Subject: Applicant's Response to Data Requests, Set 2A, #167 (11-AFC-04)

## APPLICANT'S RESPONSE TO DATA REQUEST #167

Technical Area: Biological Resources

### APPLICATION FOR CERTIFICATION FOR THE RIO MESA SOLAR ELECTRIC GENERATING FACILITY

Figure 167-1: Solar Field Cable Trench Layout and Sections

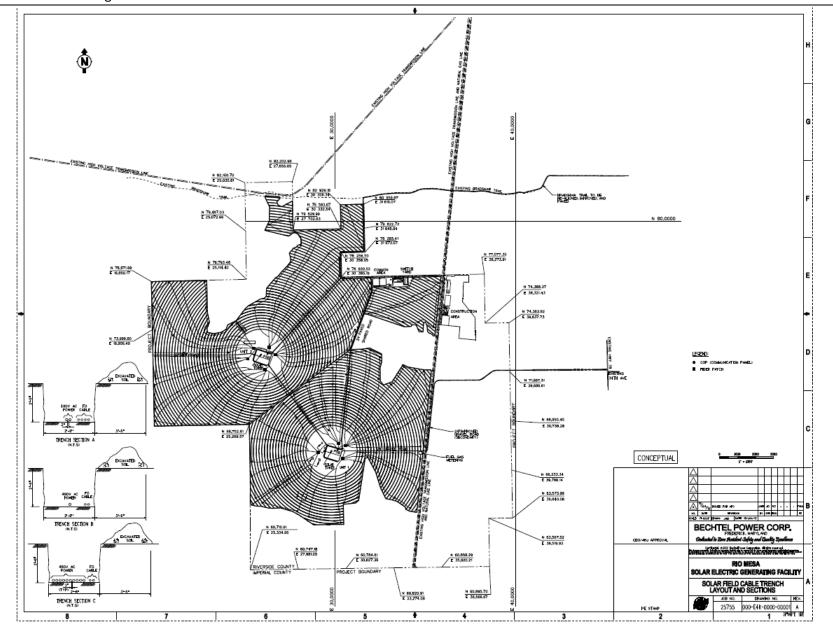
167. State whether any underground infrastructure would be required to operate the heliostats. If underground infrastructure is proposed, please describe the proposed installation methodology, including trench dimensions. Illustrate any areas of proposed ground disturbance necessary for operation of the heliostats on a map and provide drawings of representative trenches or other ground disturbance, including any berms or other grading to divert runoff.

At this stage of the solar field design, the Applicant has not yet determined the actual grouping and routing of each trench that will provide power and communication utilities to the heliostat control network distribution boxes. However, Applicant's engineers were able to determine the allowable electrical loads and communication channel capacities and have prepared a typical loop design. Based on this information, Applicant estimates the following:

- 19 loops for each solar field (RMS 1 and RMS 2)
- Average loop length of 16,000 feet (includes an allowance for field cameras and weather stations)
- Trench width of 30" which will contain 480V AC electrical service and fiber optic communication cables
- Ground disturbance for the solar field control system will be temporary and Applicant does not anticipate any permanent stormwater diversion features (berms, diversion channels) associated with this system.

Figure 167-1 is a depiction of a typical trench and is not necessarily representative of actual route through the field.
